Warranty Field Campaign

Campaign Number: c2101	Revision: A	Released Date: 10-Feb-2020
ISV 5.0L Belt Slip Safety Campaign for Blue Bird Bus		Expiration Date (U.S. and Canada): 15-Jan-2045
		Expiration Date (International): 15-Jan-2045

ISV Secondary Belt Drive – Upfit Installation Instructions

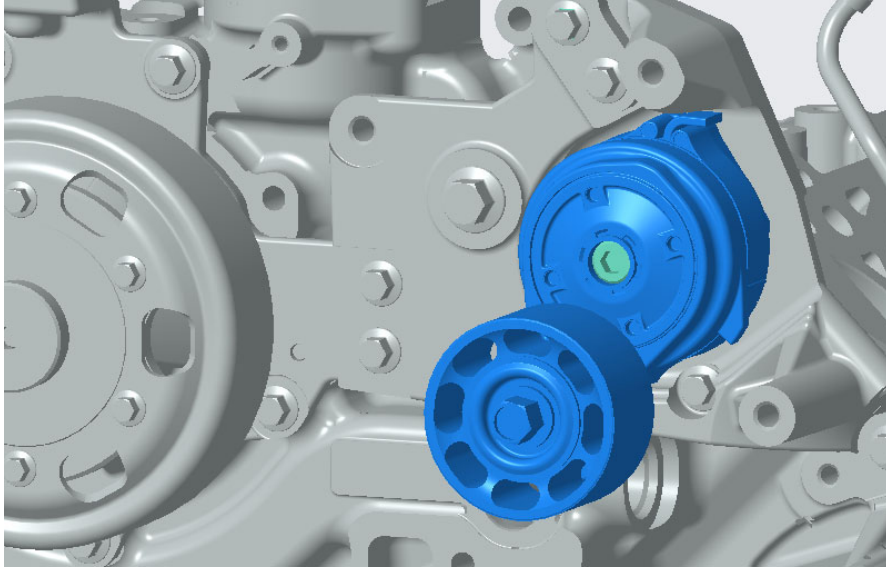
Install new tensioner bracket 5572555. See below figure for capscrew part numbers and torque specification.

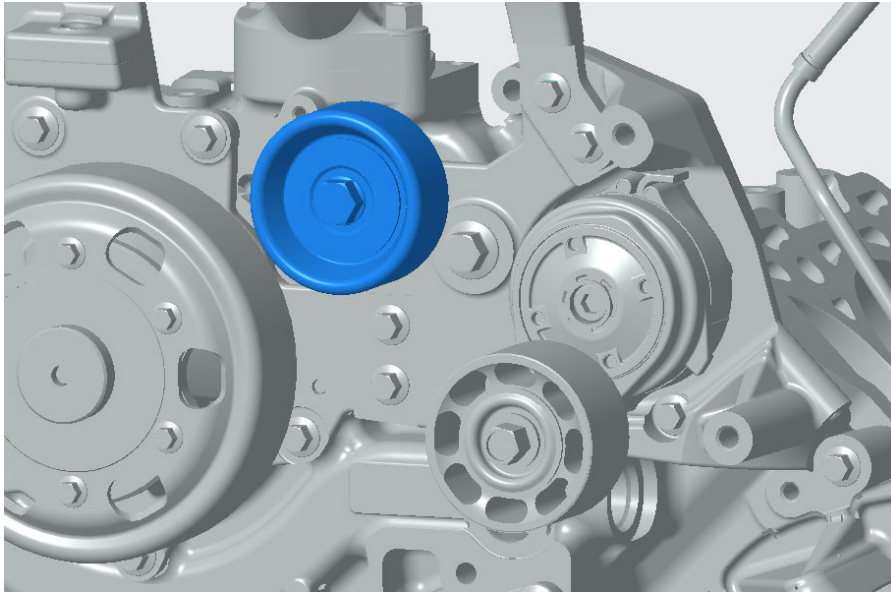
Install belt tensioner 4316721 using capscrew 4324936. Torque: 65 N-m [50 ft-lb]

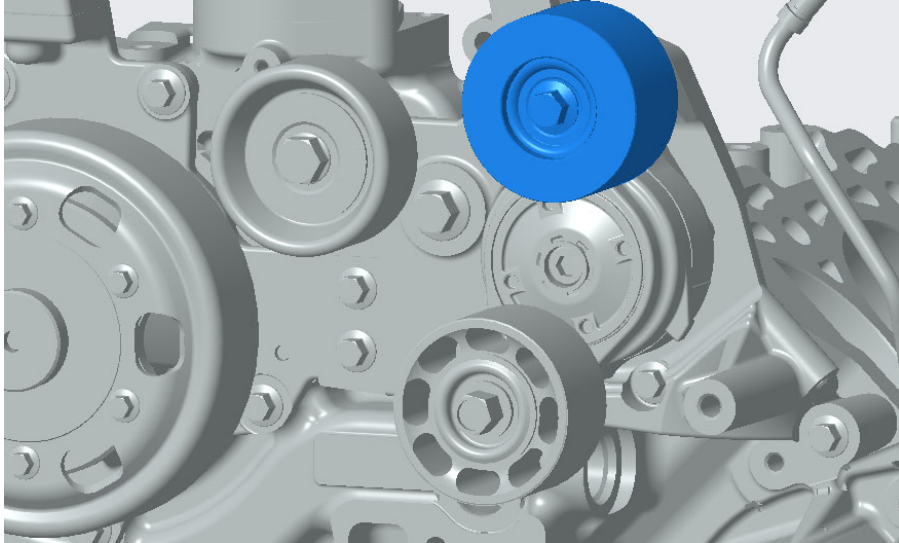
Install idler pulley assembly 4390737 (integrated capscrew). Torque: 34 N-m [25 ft-lb]

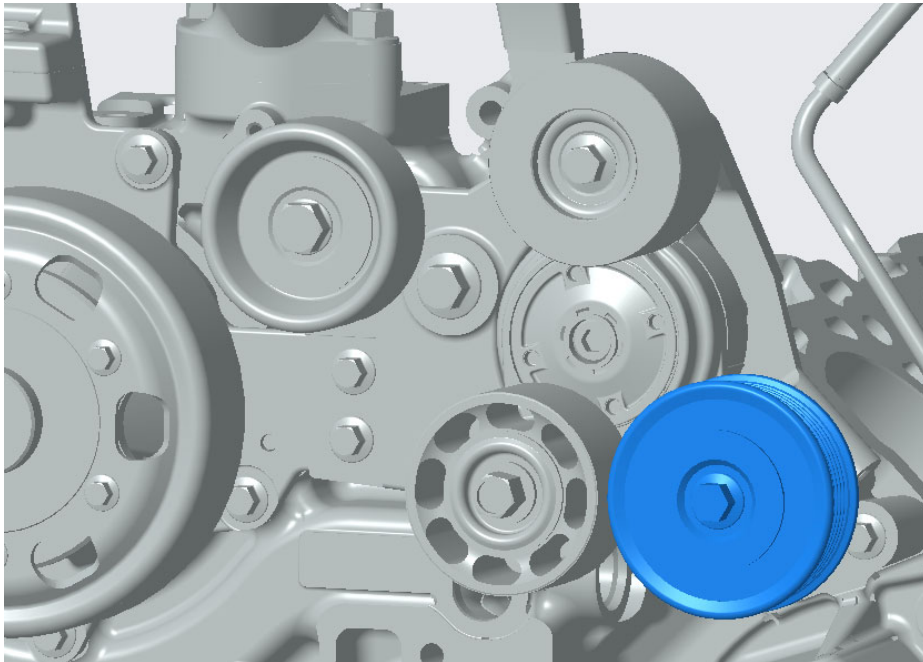
Install idler pulley assembly 5598353 (integrated capscrew). Torque: 65 N-m [50 ft-lb]

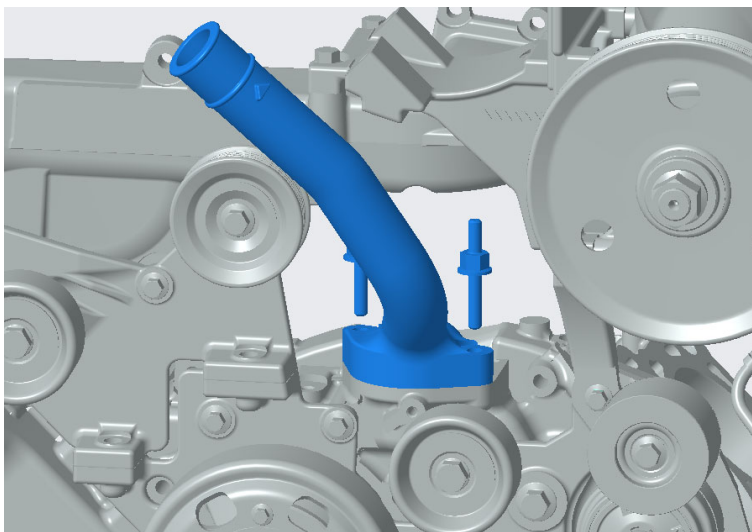
Remove thermostat housing 4335418. Retain capscrews (4325276). Retain thermostat.

Install thermostat into new thermostat housing 5414320. Install thermostat housing 5414320 as shown in the figure below. Use same capscrews 4325276. Refer to procedure 008-157-tr. Torque: 18 N-m [159 in-lb]

Coolant Hose Modification

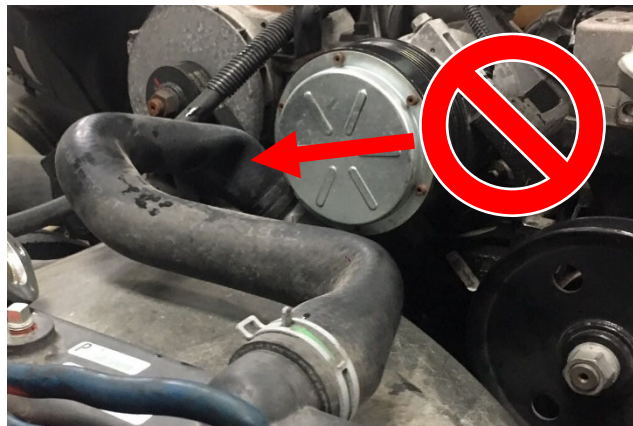
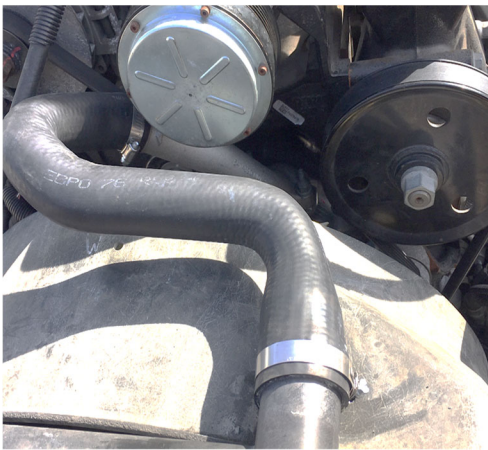
The coolant hose from the thermostat housing to the radiator must be modified to prevent kinking with the new design. Please follow the following steps to modify the coolant hose:

1. Remove the coolant hose from the vehicle.
2. Identify the end that connects to the thermostat housing (engine side). This will be the narrower end.
3. Mark 70 mm (2.75 in) from the end using a pen or marker.
4. Use a sharp utility knife to cut the hose. Try to cut the hose perpendicular to the edge. Make sure not to remove too much. More length can be removed if it does not fit properly.

Remove 70 mm (2.75 in.) from engine side of hose

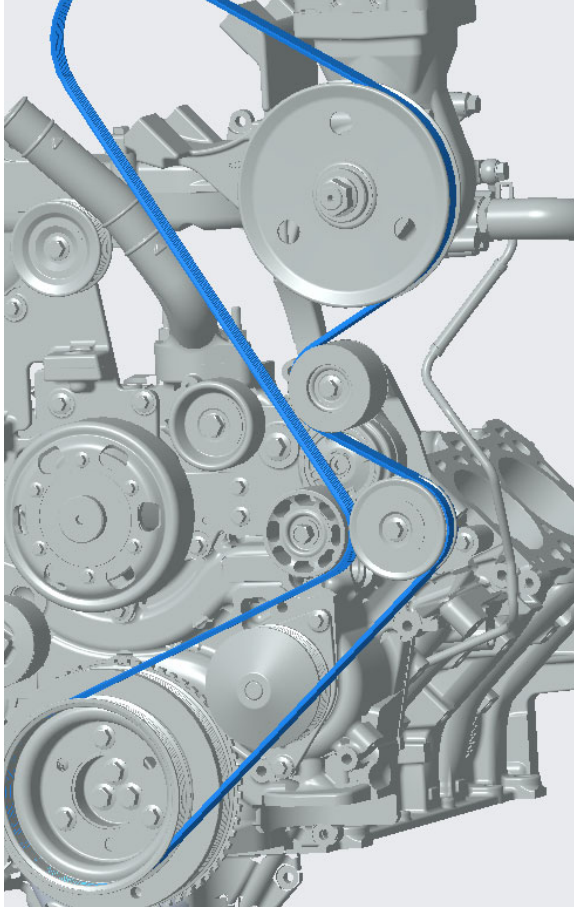
Install new belt 5414317. Refer to procedure 012-117-tr.
